PRODUCT CHANGE NOTIFICATION

PCN No.: PCN-202512-066	**PCN Doc No.:** EC-20251226-PCN-11	**Date Issued:**	12/26/2025
Part Number or Series: PH2-XX-UA-SMT		**PCN Effective Date:**	12/26/2025
Customer: (If applicable)		**P/O No.: (If applicable)**	Not affected
Type of Change:	■ Mfg location Change / Qualification / Country of Origin (COO) ■ Design Change / Data Sheet Spec Change	**Last Time Buy Date:**	Not affected
Traceability Marking/Date code: No change		**Last Time Ship Date:**	Not affected
Replacement Part Number: PH2-XX-UA-SMT-Y		**Sample Availability Date:**	Not affected

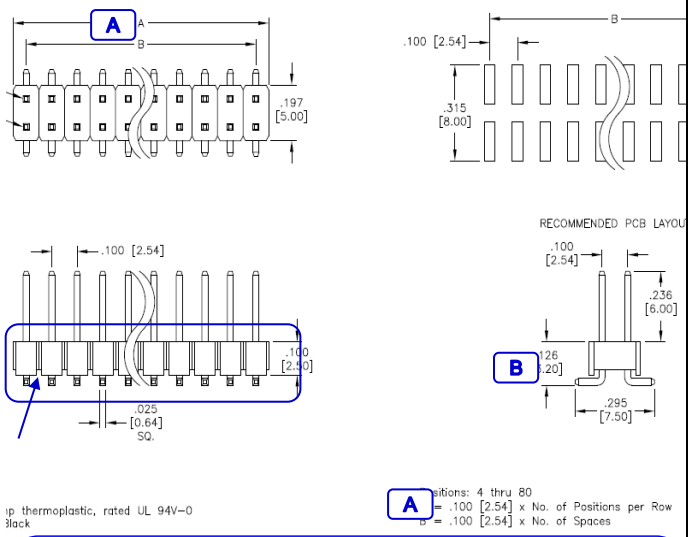
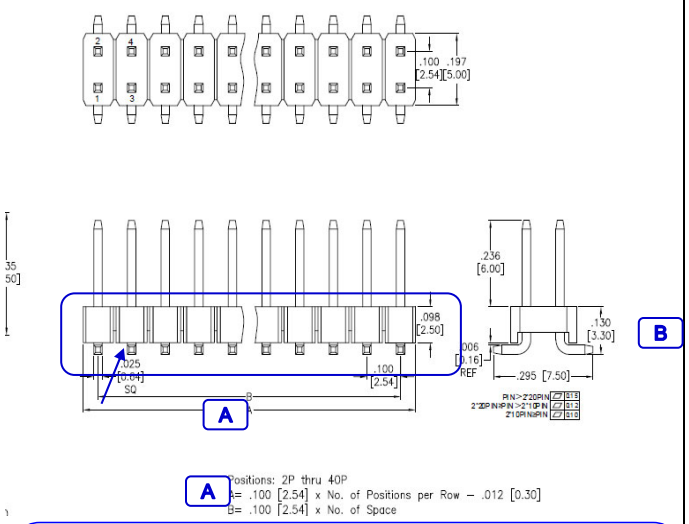
Impact of Change: P/N change, There are slight differences in appearance and size;

Before the change:
1、Appearance ~ As shown in the above picture;
2、Size:
A) A=.100[2.54] x No. of Positions per Row
B) 3.20mm

After the change:
1、Appearance ~ As shown in the above picture;
2、Size:
A) A=.100[2.54] x No .of Positions per Row -.012 [0.30]
B) 3.30mm
